LIDCO, Pars SEE Zone, Assaluyeh,
Integrated Methanol and Ammonia
Plant 3000 MTPD MeOH / 900 MTPD NH3 PROJECT

Document No. 17735-03

**Airpack B.V. - Air Compressor –
Integrated Methanol and Ammonia Plant
17735-COM Piping & Instrument Diagram (K020)**

DRAWING TITLE:
P&ID for High Pressure Air Compressor K020

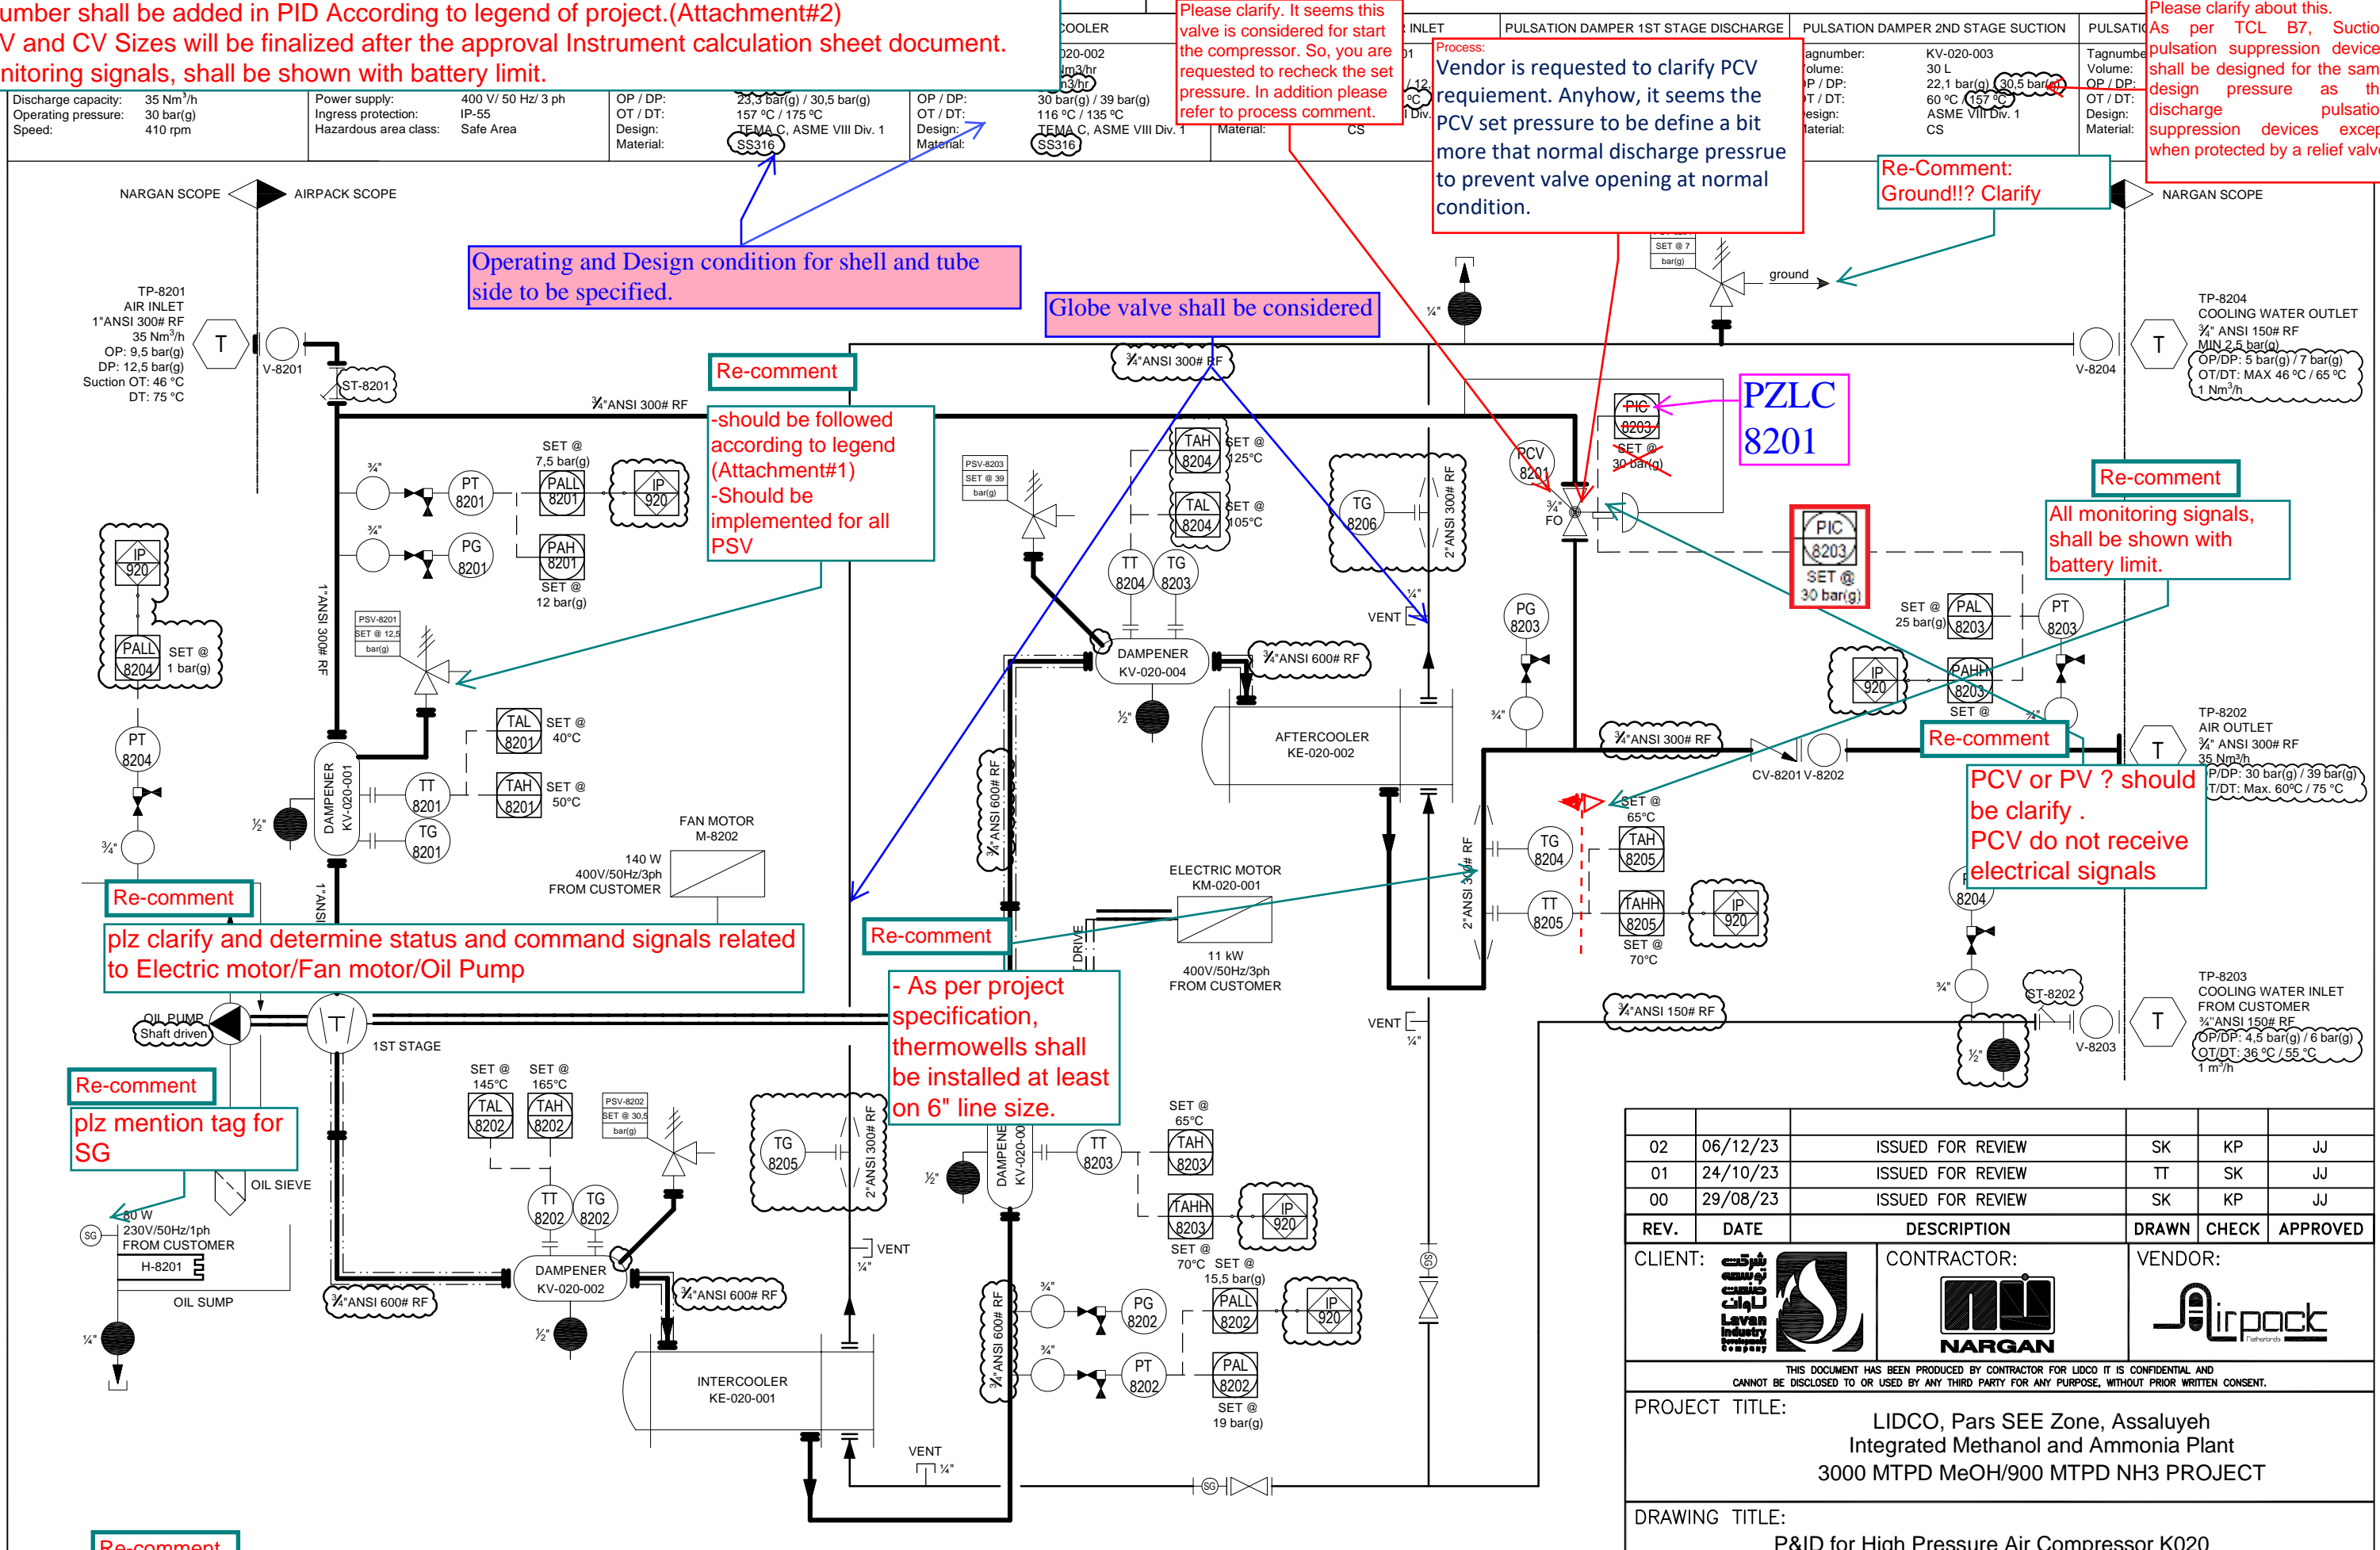
- Line number shall be added in PID According to legend of project. (Attachment#2)
- All PSV and CV Sizes will be finalized after the approval Instrument calculation sheet document.
- All monitoring signals, shall be shown with battery limit.

Please clarify. It seems this valve is considered for start the compressor. So, you are requested to recheck the set pressure. In addition please refer to process comment.

Vendor is requested to clarify PCV requirement. Anyhow, it seems the PCV set pressure to be define a bit more that normal discharge pressure to prevent valve opening at normal condition.

Re-Comment: Ground!!? Clarify

Please clarify about this. As per TCL B7, Suction pulsation suppression devices shall be designed for the same design pressure as the discharge pulsation suppression devices except when protected by a relief valve

Operating and Design condition for shell and tube side to be specified.

Globe valve shall be considered

Re-comment
-should be followed according to legend (Attachment#1)
-Should be implemented for all PSV

Re-comment
All monitoring signals, shall be shown with battery limit.

Re-comment
plz clarify and determine status and command signals related to Electric motor/Fan motor/Oil Pump

Re-comment
- As per project specification, thermowells shall be installed at least on 6" line size.

Re-comment
PCV or PV ? should be clarify .
PCV do not receive electrical signals

Re-comment
plz mention tag for SG

Re-comment

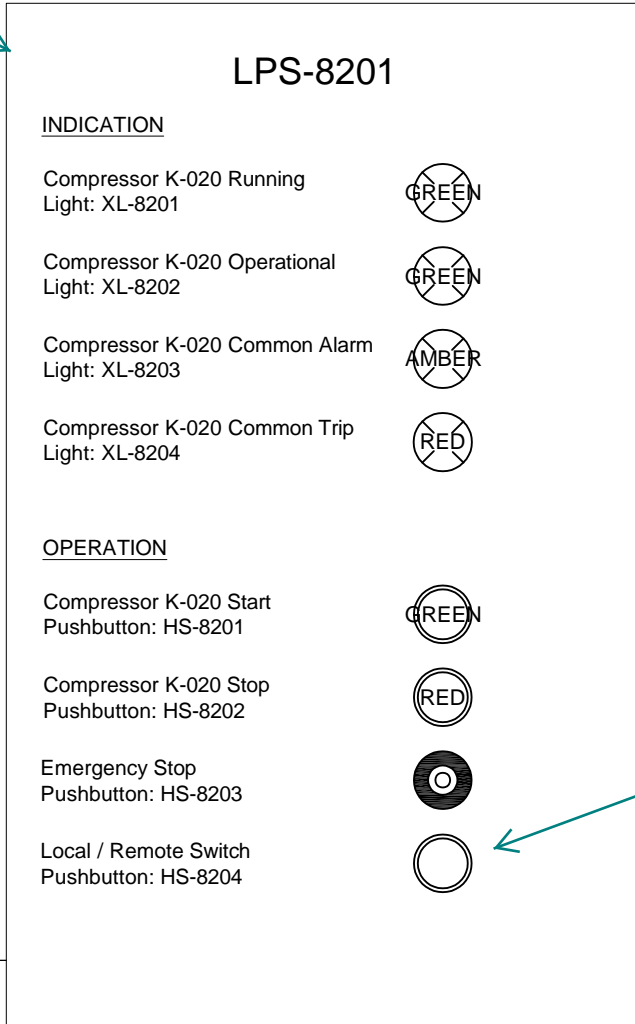
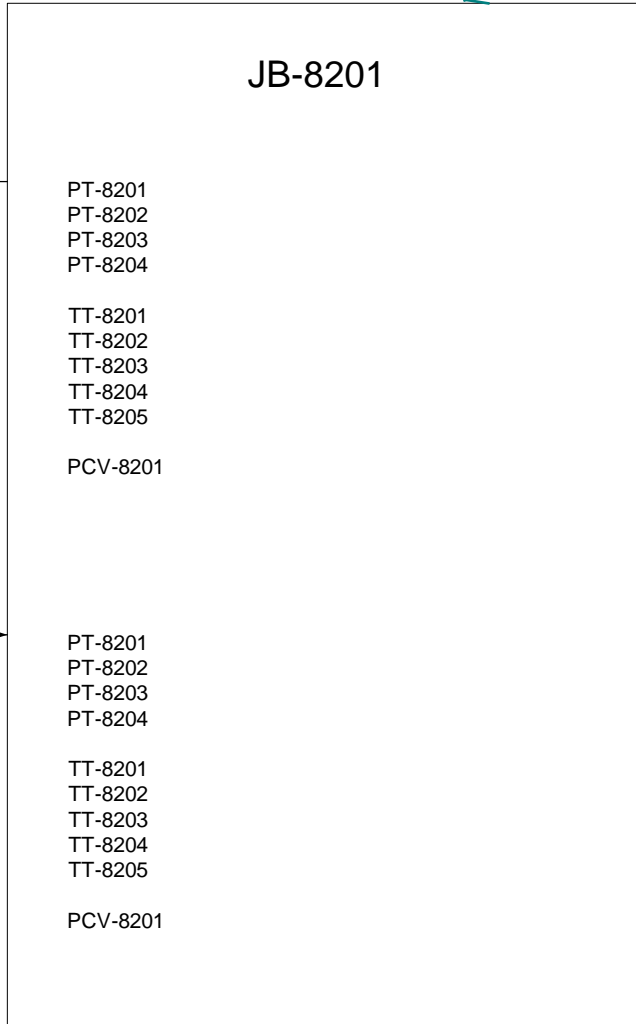
Tag name should be modified.
300LP-820
300JDAN-820
Re-comment

DRAWING TITLE:
P&ID for High Pressure Air Compressor K020

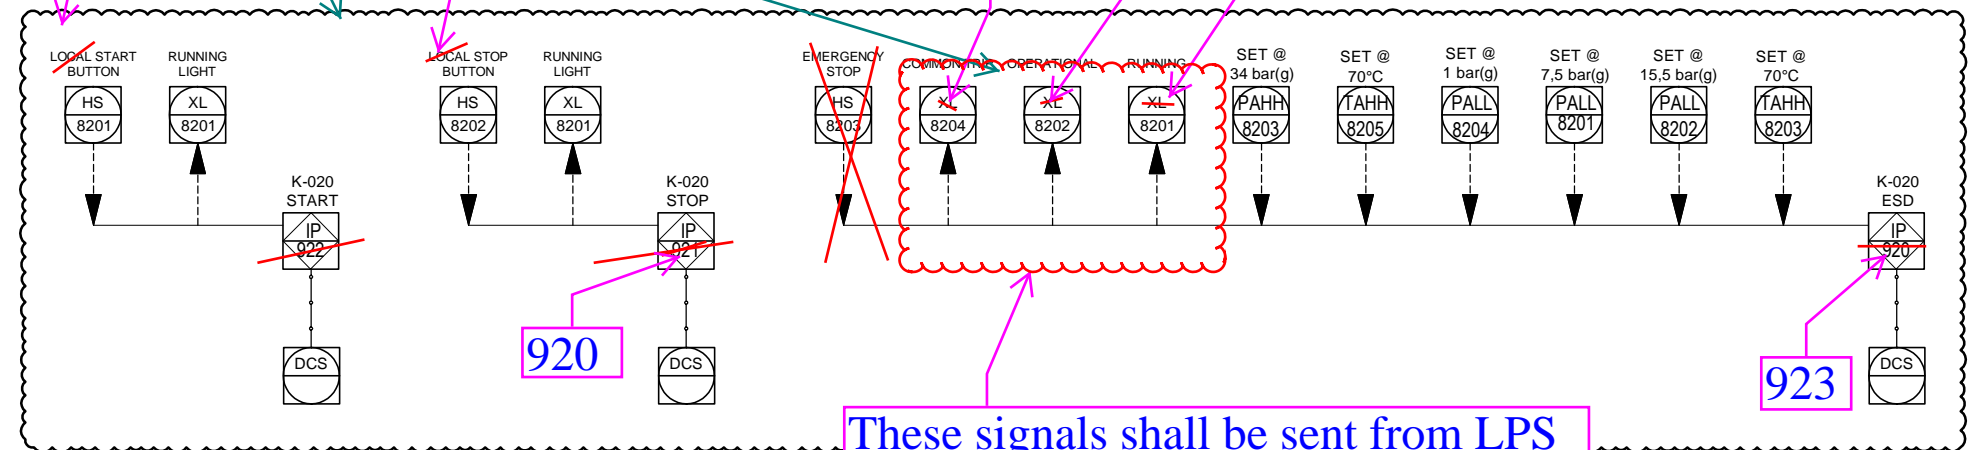
Re-comment
selector switch symbol should be modified

As per PID of project, interlocks and tag name (ML/XA/YL) should be modified

These signals shall be sent from LPS to DCS. Please separate from other
